ADDENDUM NO. 1

Date of Addendum: 3/19/15

PROJECT NAME: Northwest Wastewater Treatment Plant Improvements

PROJECT NO: WBS No. R-000265-0095-4

WBS NO. R-000265-0095-4
DRAWING SCALE
NTS
CITY OF HOUSTON PM
BILL ZOD, P.E.
E-14 SHEET NO. 30 OF 137

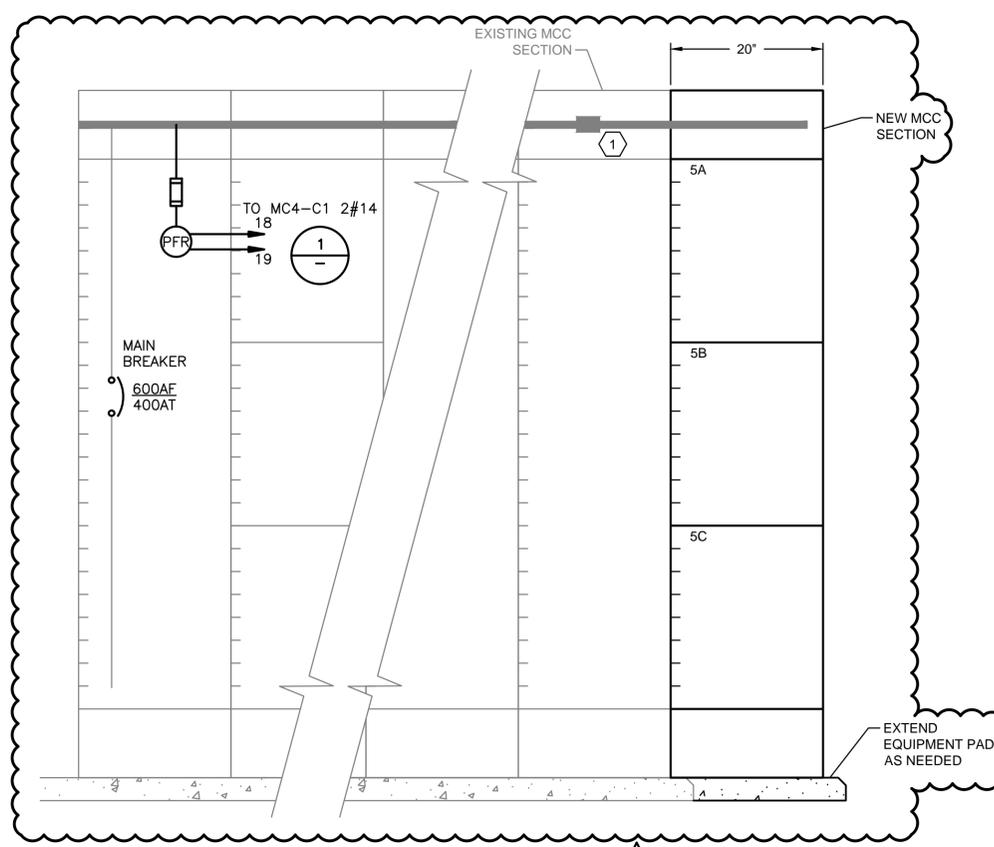
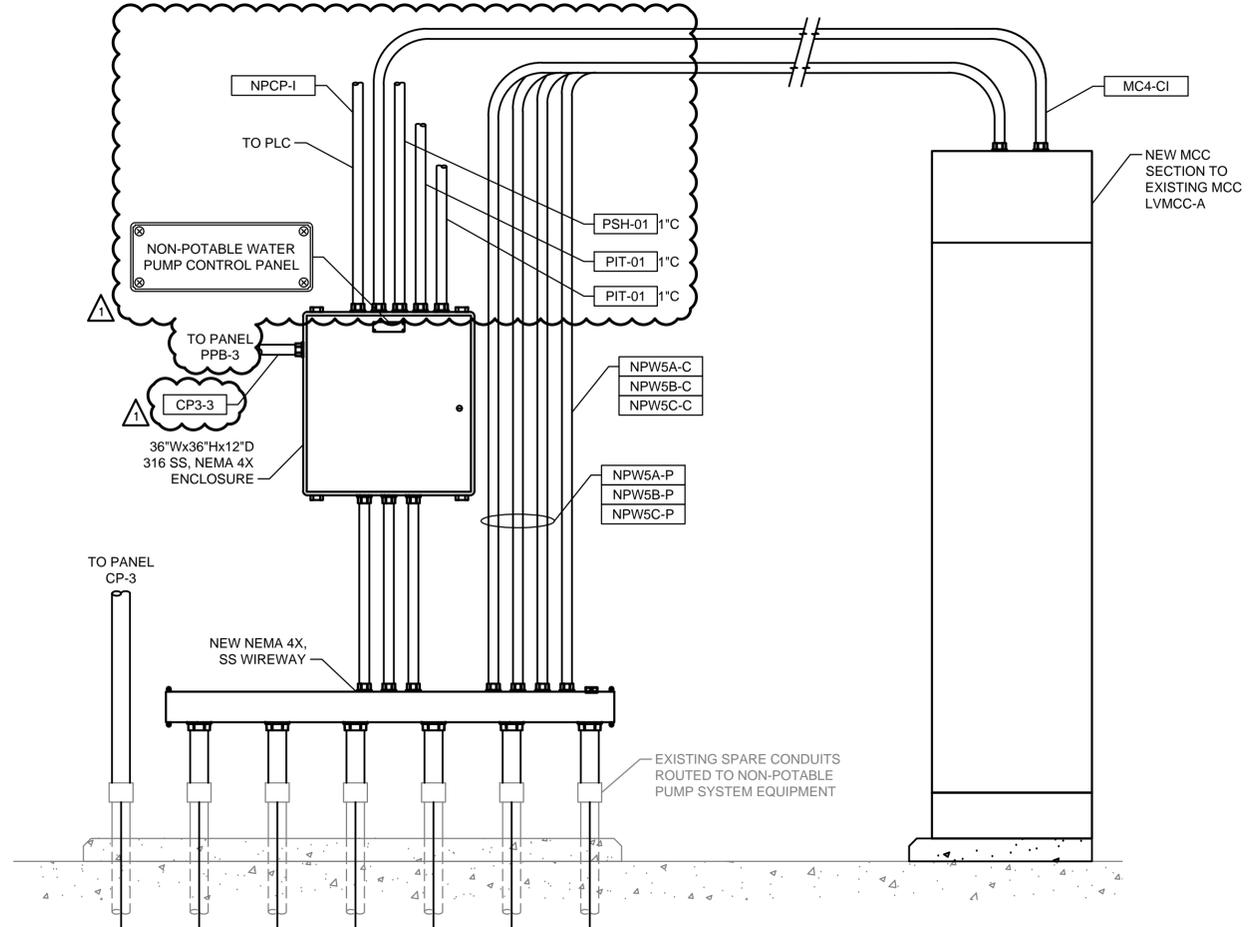
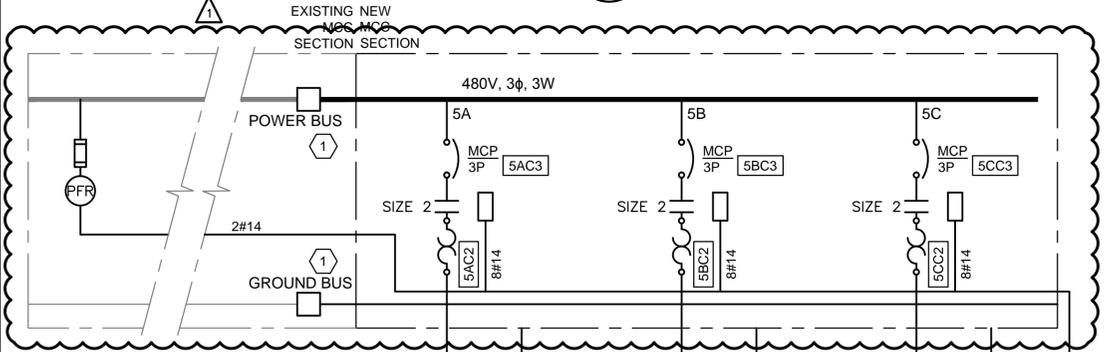
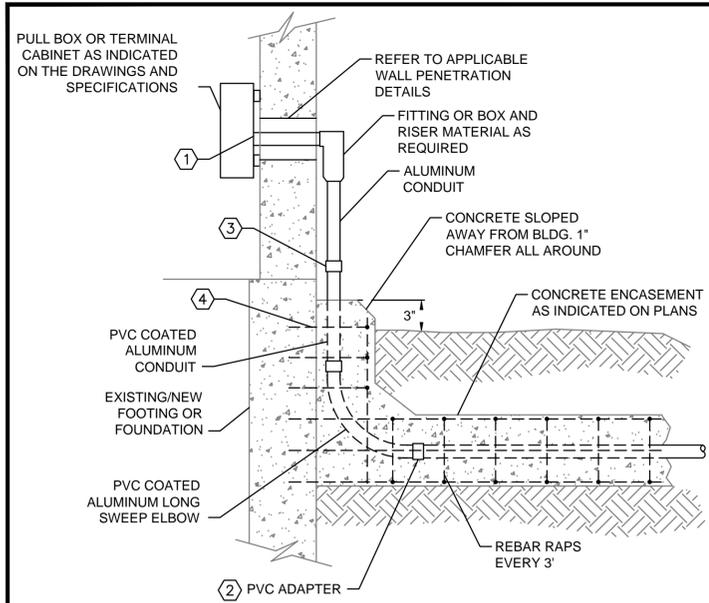
47. Per sheet 30, Detail 1 conduit MC4-C1, what is the size of the conduit and how many conductors are to be installed?

Refer to revised drawings E-14 (sheet 30) for clarifications per Addendum No. 1

WBS NO. R-000265-0095-4
DRAWING SCALE
NTS
CITY OF HOUSTON PM
BILL ZOD, P.E.
EZ-2 SHEET NO. 39 OF 137

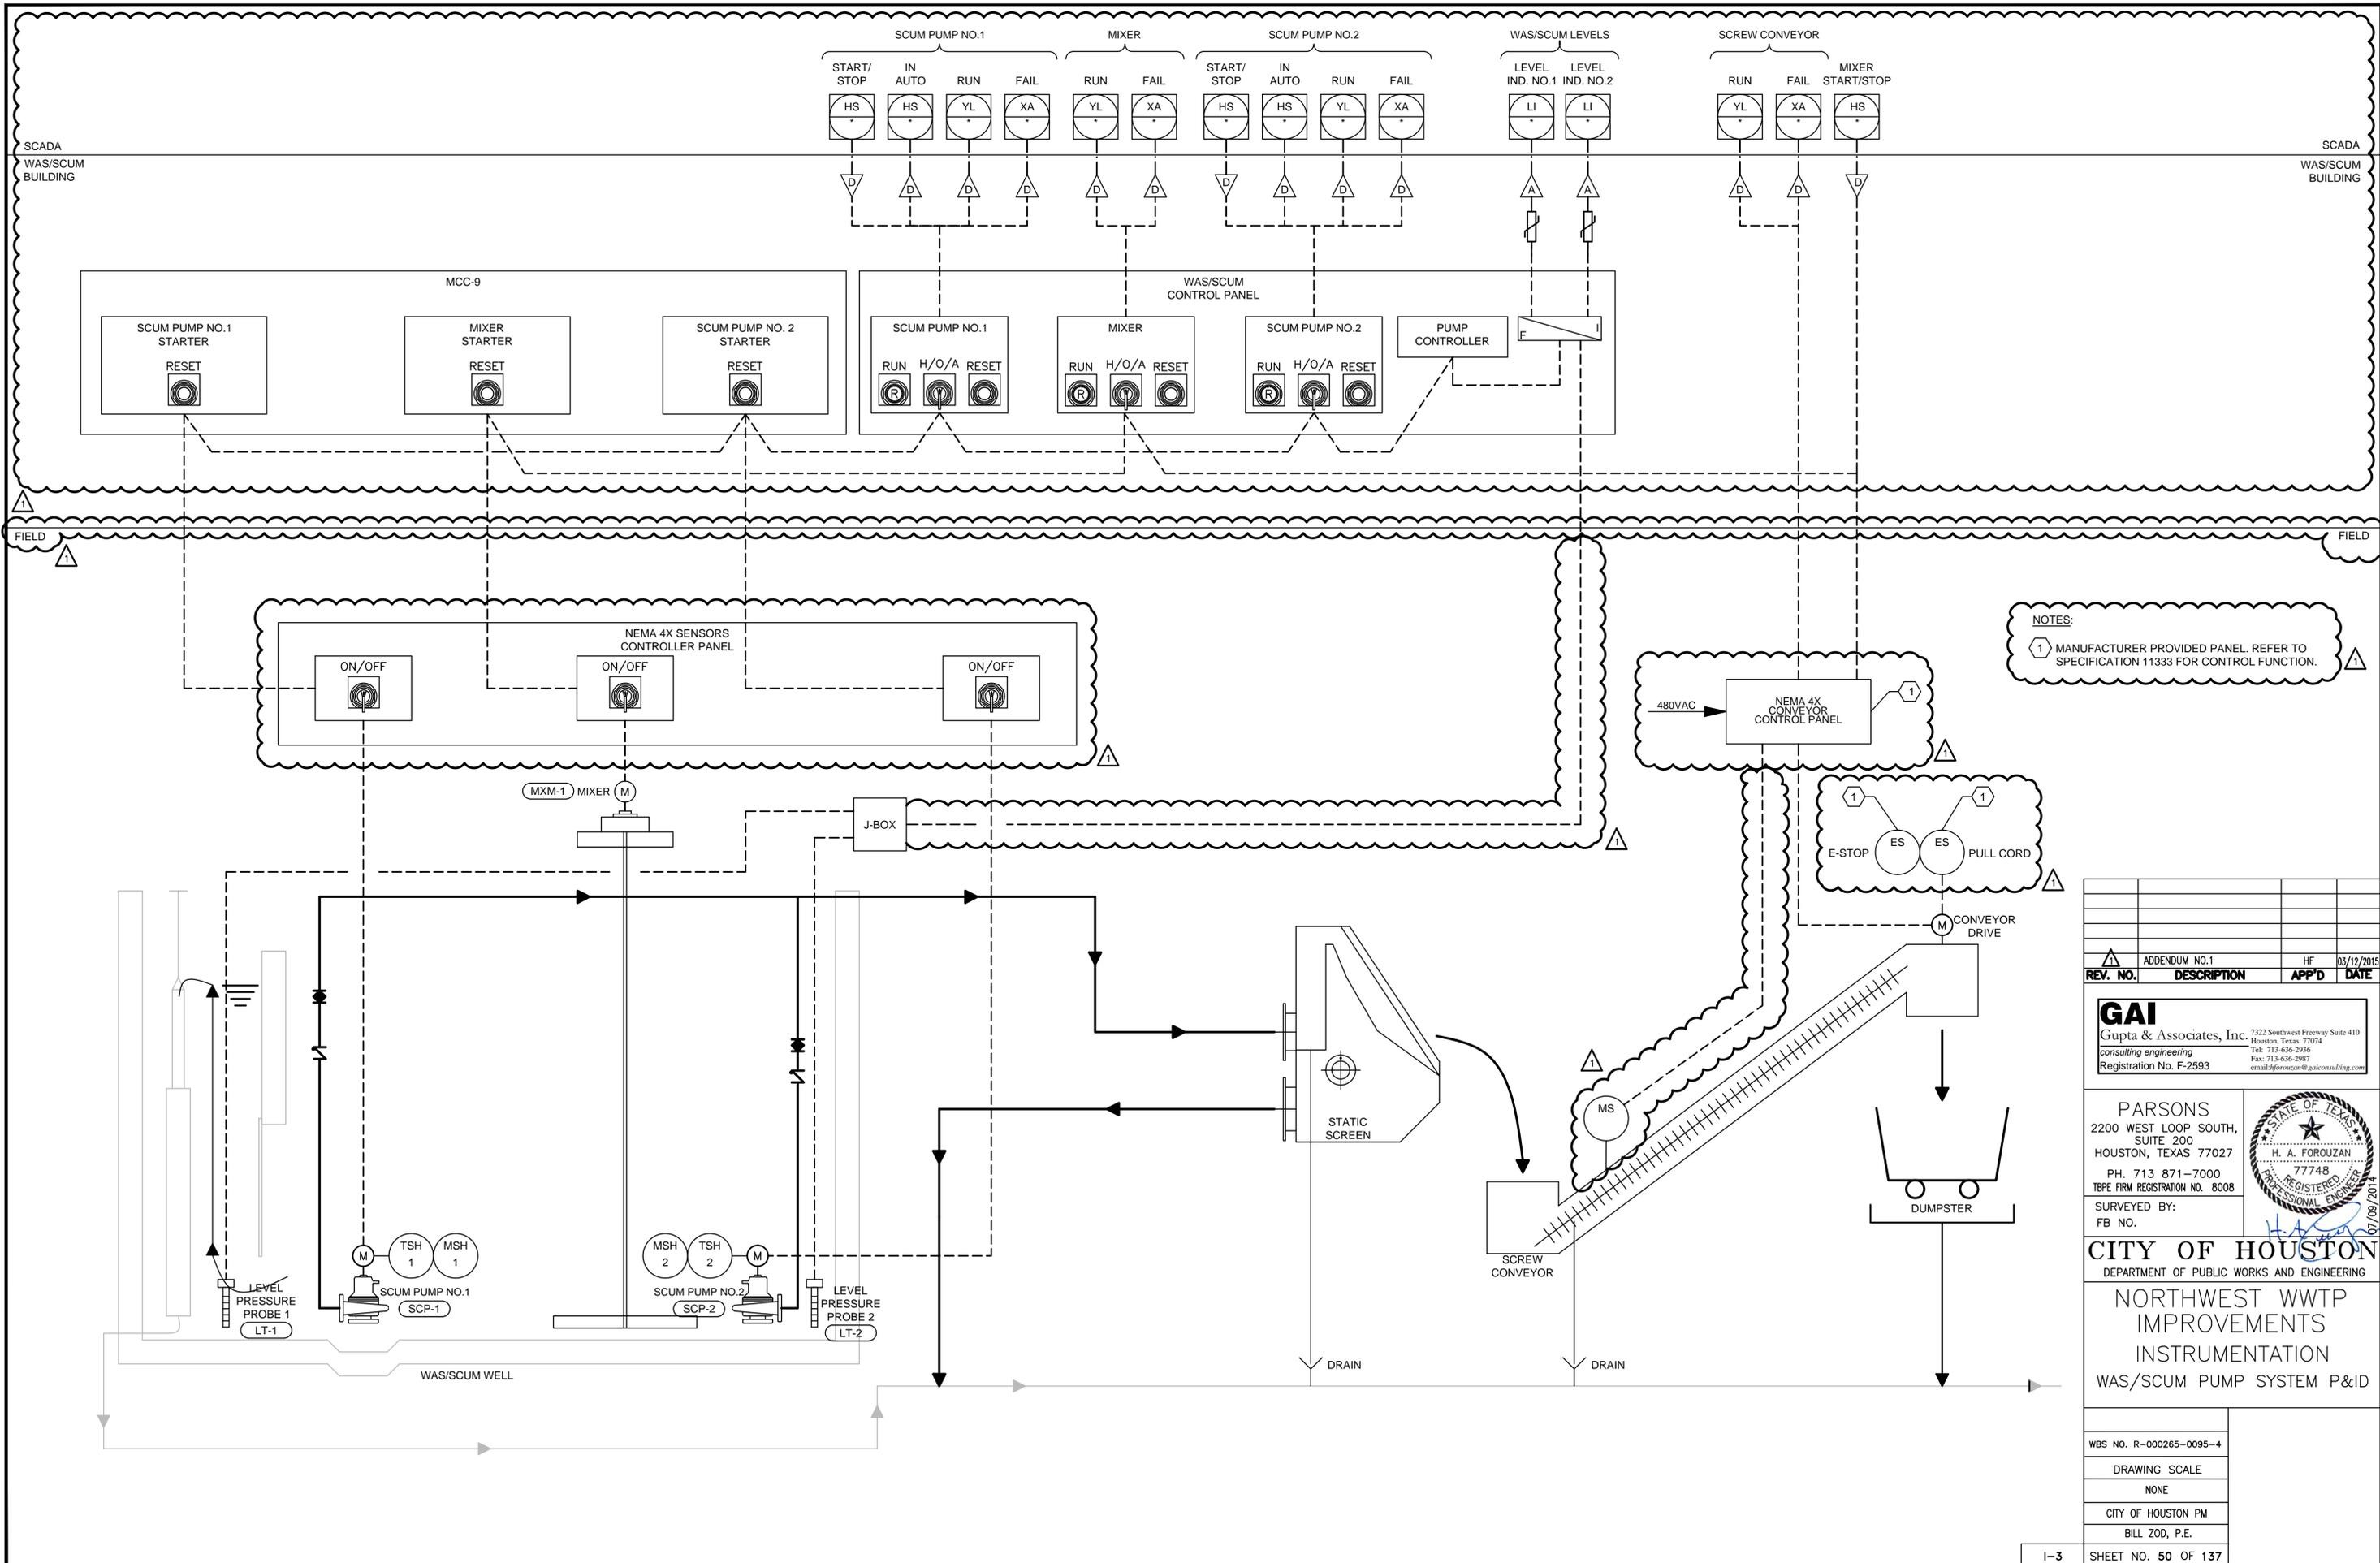
53. Per sheet 21, where are PJB-3, PB-1 and PB-2 located on sheet 20? Please Clarify.

PB-1 and PB-2 are no longer necessary to use the existing spare conductors. PJB-3 is located on the pull box 15 drawings E-4 (sheet 20) and additional detail is provided per revised EZ-2 drawing for modification and termination for the new MCC-9 feeders and PJB-3.

WBS NO. R-000265-0095-4
DRAWING SCALE
NONE
CITY OF HOUSTON PM
BILL ZOD, P.E.
I-3 SHEET NO. 50 OF 137

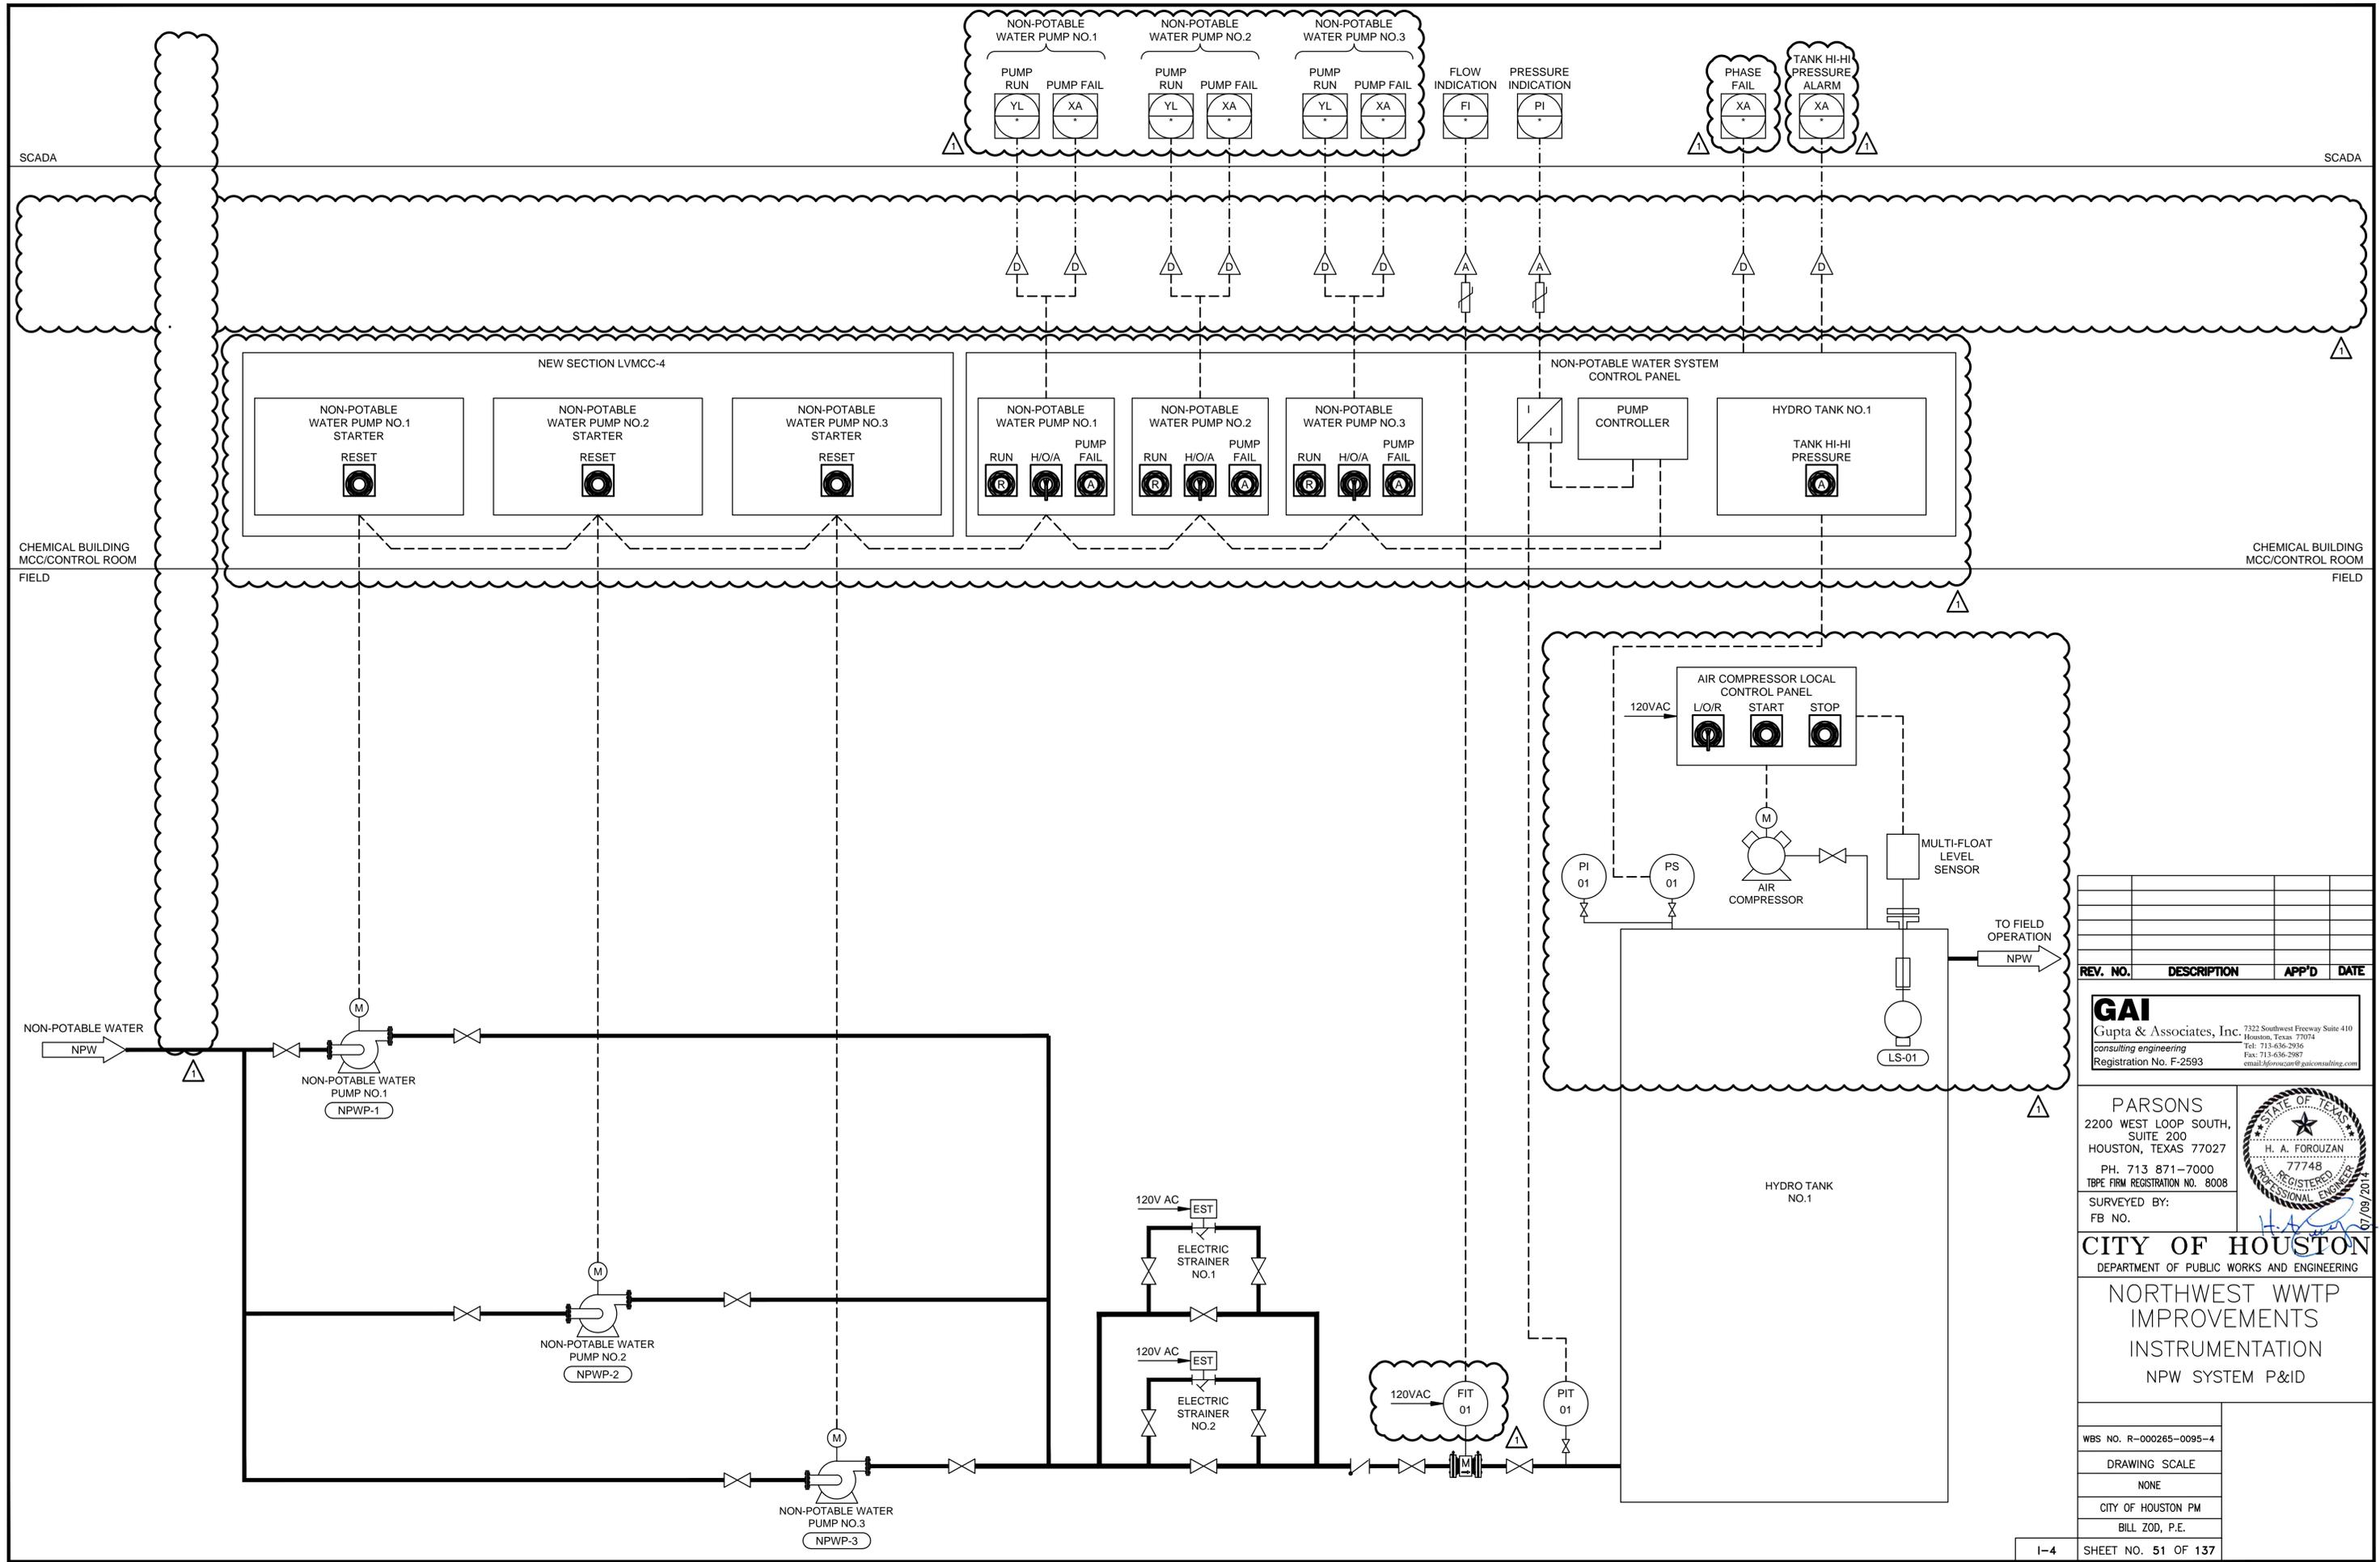
49. Per sheet 50, the Scum & Screw Conveyor control panel isn't shown on the P&ID drawing. For example, see sheet 51. Please clarify. (show detail on drawing)

Refer to revised drawings I-3 (sheet 50) and I-5 (sheet 51) for clarifications per Addendum No. 1
